Suntop Solar Farm (Mod 1)

*State Significant
Development
Modification Assessment
(SSD 8696 MOD 1)*

October 2019

Figure 2 | Comparison of Approved and Proposed Substation Layout

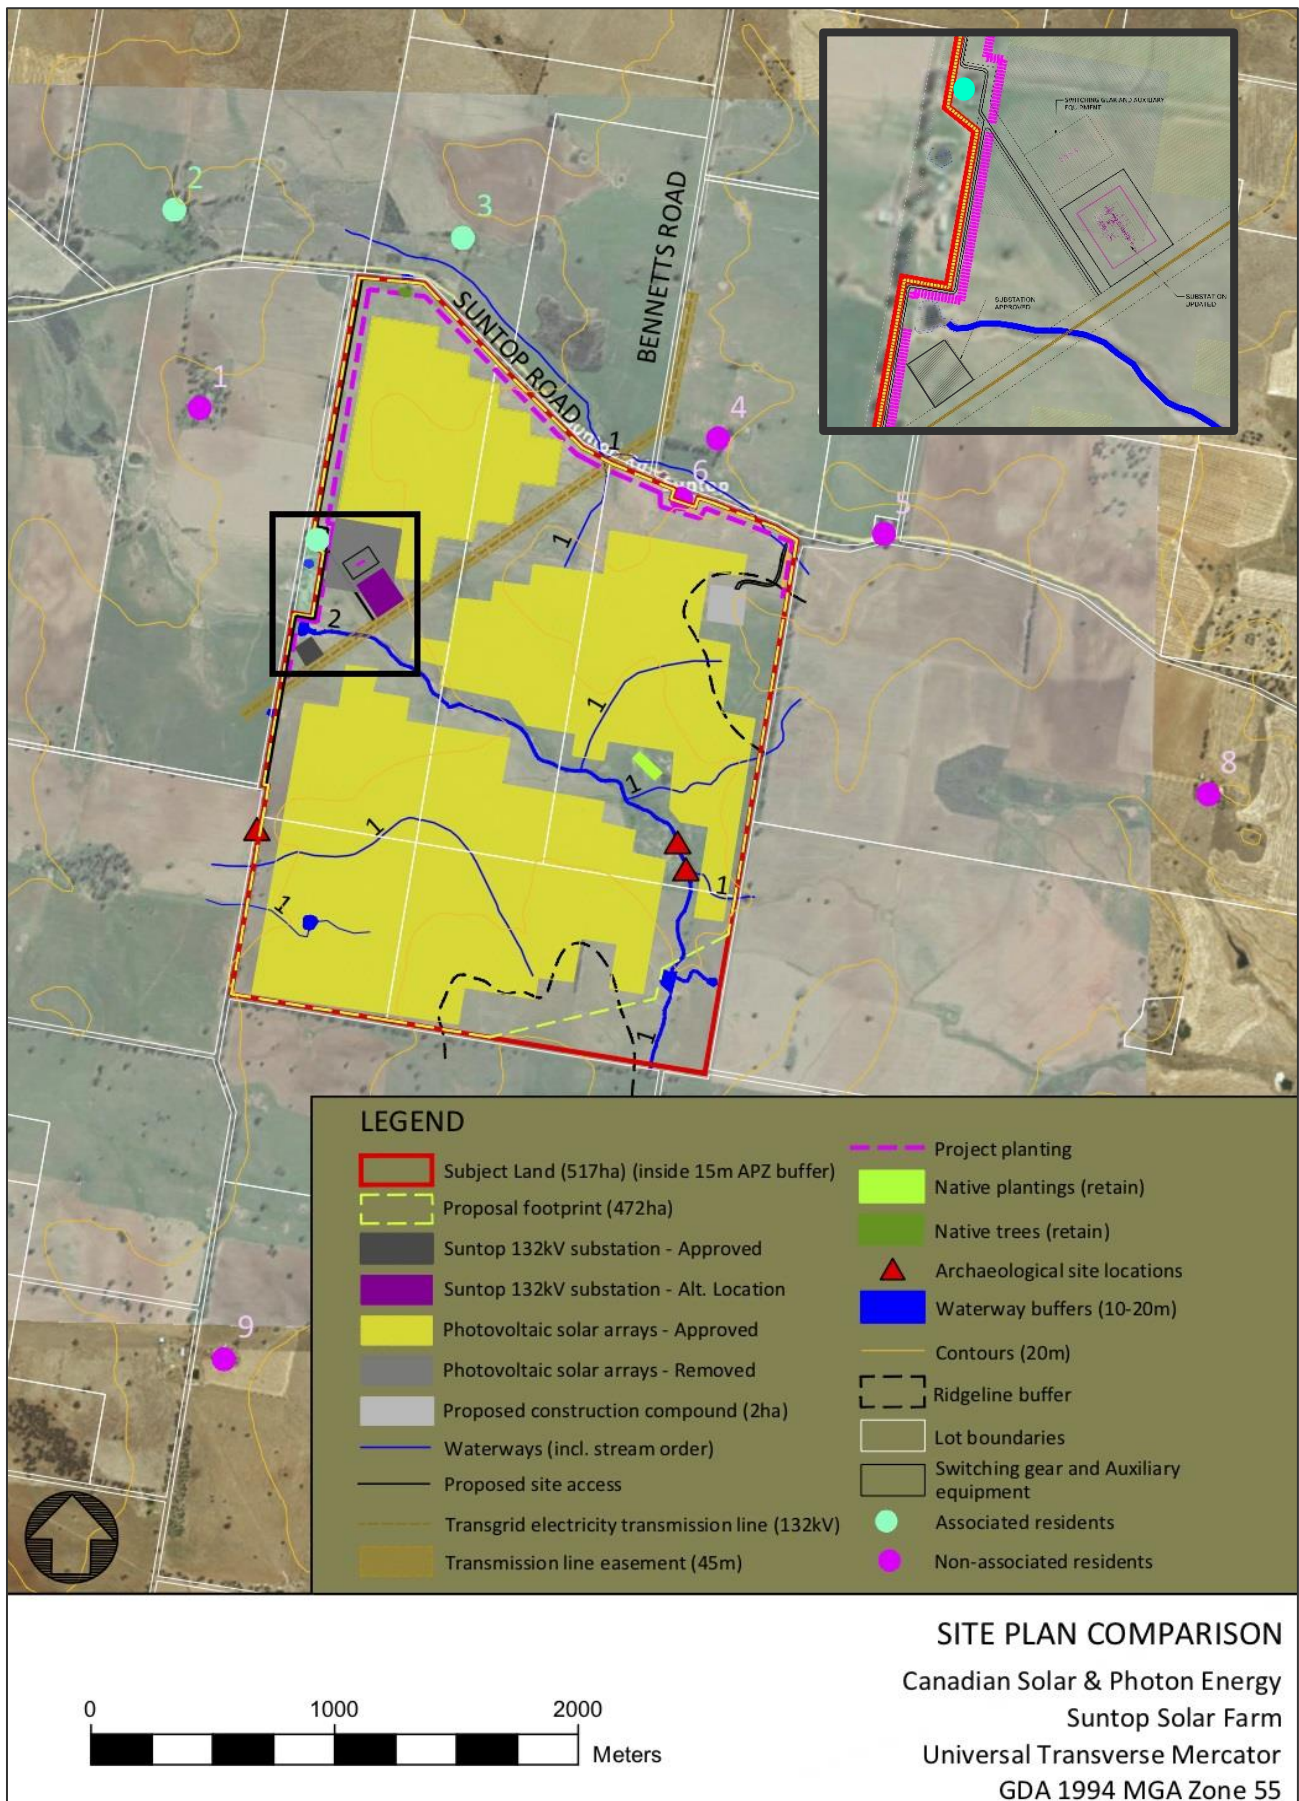
TransGrid requested the substation location be further revised to abut the existing transmission line easement, to avoid the need for further work to connect to the transmission line. SSF revised the relocation of the substation to address these comments and is depicted in **Figure 2** and **Figure 4**.

Four community members raised concerns about the increased visual impact of the proposed substation changes on residential receivers and while travelling on Suntop Road, including the closest receiver (R1) to the proposed substation.

Although the proposed changes would result in the substation being located about 200 m closer to R1 to the west, there would still be approximately 900 m between R1 and the relocated substation. In addition, the Department considers that existing vegetation, the approved and proposed continuous landscaping screening and the vacant dwelling on site would provide adequate mitigation from the visual impacts of the relocation.

The approved vegetation screening on the western boundary was designed to augment existing native vegetation. The modification seeks to supplement the approved vegetation screening to form a continuous buffer along the western boundary to provide screening from the proposed substation location (see **Figure 2**).

Figure 4 | Location of Lot 2 in the Proposed Subdivision Plan

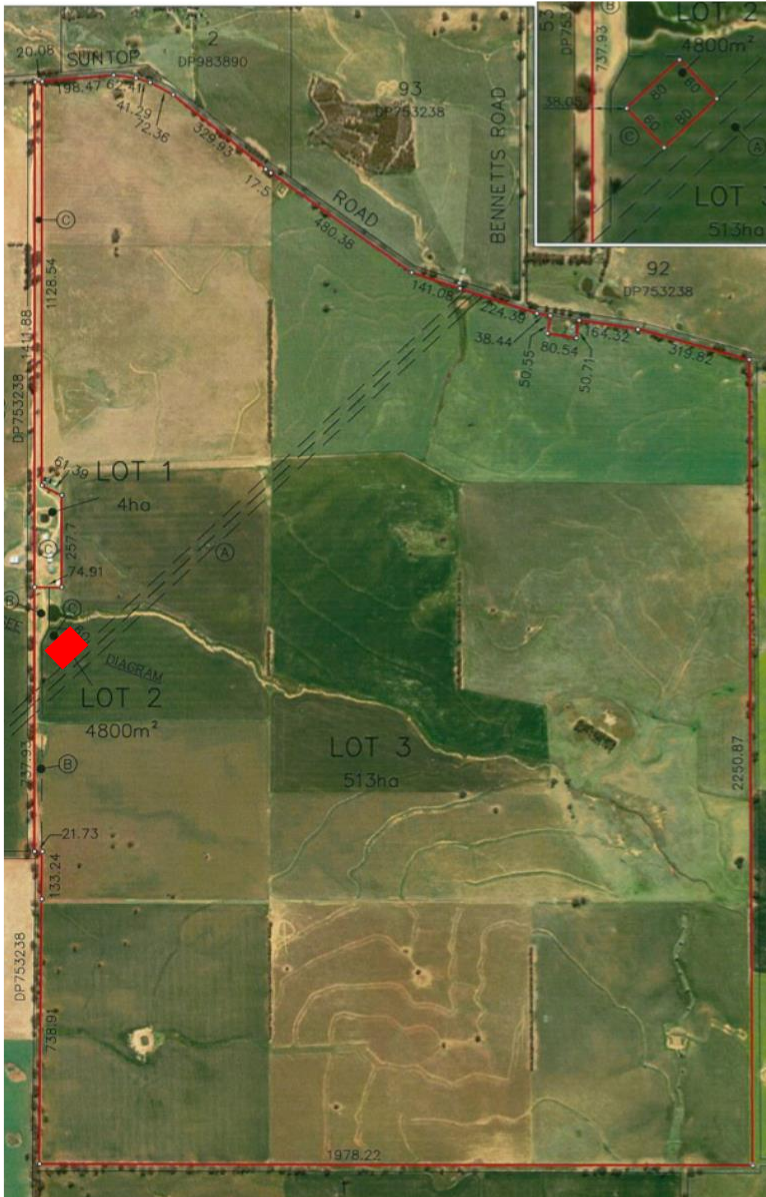
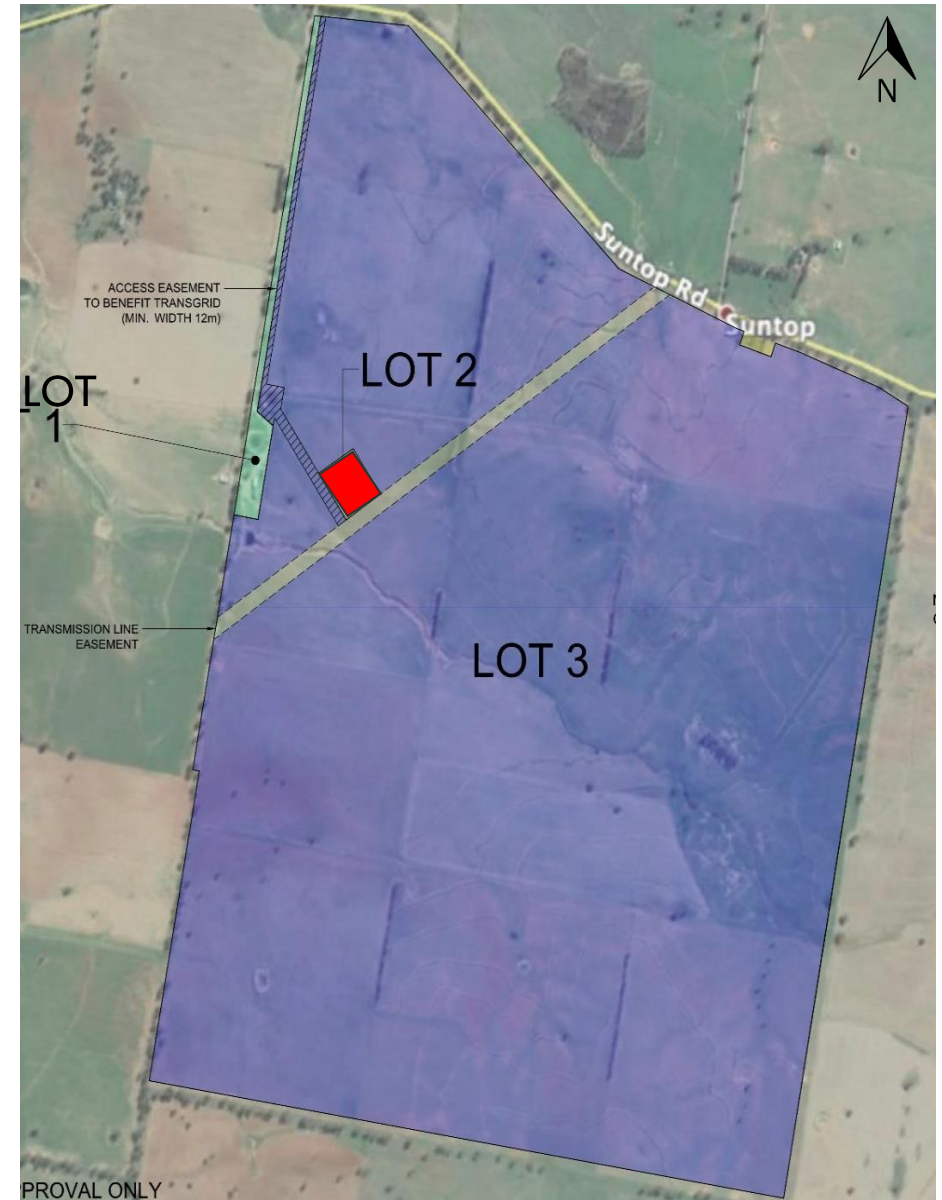
The proposed substation changes would result in consequential changes to the location and dimension of Lot 2 in the subdivision plan as shown in **Figures 3** and **Figure 4**. As such, the modification proposes the following changes to the subdivision plan:

- relocation of Lot 2 to align with the proposed substation location; and
- increase the size of Lot 2 to approximately 2 ha to allow for the proposed substation expansion.

The revised subdivision is consistent with the existing development consent, merging the existing five lots into three new lots. As such, the Department considers the revised subdivision plan should be approved as it:

- is necessary to address TransGrid's connection requirements and for the operation of the substation;
- would not result any additional dwelling entitlements on the subdivided lots; and
- is consistent with the key objectives of the RU1 zone as it would encourage diversity and primary industry enterprises and minimise conflict between land uses.
